Access Compliance Report

Public Rights-of-Way

(Curb Ramps)

Intersection ID: 12304	Main Street: COBBLERIDGE_DR	Cross Street: SHAMROCK_DR	Location: SW
ADA ID: 3BDF53A37F21	Ramp Type: PerpDiag	Initial Pass/Fail: Fail	Overall Compliance: No
		Severity Score: 22.5

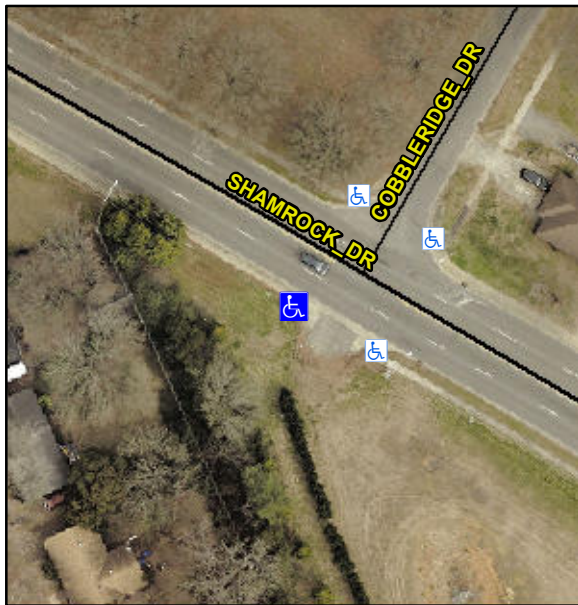
Not Found, R304.5.1, R304.2.2

Compliance	Description	Data	Compliance	Description	Data
N/A	Ramp Length (in)	58.5	No	Ramp Slope (%)	8.4
No	Ramp Width (in)	40.0	Yes	Ramp XSlope (%)	2.5
N/A	Flare Type LT	N/A	N/A	Flare Type RT	N/A
N/A	Flare Slope LT (%)	N/A	N/A	Flare Slope RT (%)	N/A
N/A	Flare Traversable LT?	N/A	N/A	Flare Traversable RT?	N/A
N/A	Landing Length (in)	N/A	N/A	DWS Provided?	N/A
N/A	Landing Width (in)	N/A	N/A	DWS Contrast?	N/A
N/A	Landing Slope (%)	N/A	N/A	DWS Length (in)	N/A
N/A	Landing X Slope (%)	N/A	N/A	DWS Full Width?	N/A
N/A	Landing Curb? (Y/N)	N/A	N/A	DWS Offset (in)	N/A
N/A	Shared Landing?	N/A			
N/A	Gutter Ponding?	N/A	N/A	Gutter Slope (%)	N/A
N/A	Gutter Lip Ht (in)	1.0	N/A	Gutter X Slope (%)	N/A
N/A	Painted X Walk1?	No	N/A	Painted X Walk2?	No
	X Walk 1 Direction	To SE		X Walk 2 Direction	To NE
N/A	X Walk 1 Width (in)	N/A	N/A	X Walk 2 Width (in)	N/A
	X Walk 1 Slope (%)	2.7		X Walk 2 Slope (%)	2.1
	X Walk 1 X Slope (%)	2.1		X Walk 2 X Slope (%)	1.5

Remove & Replace Curb Ramp With Two New Directional Ramps or Equivalent.
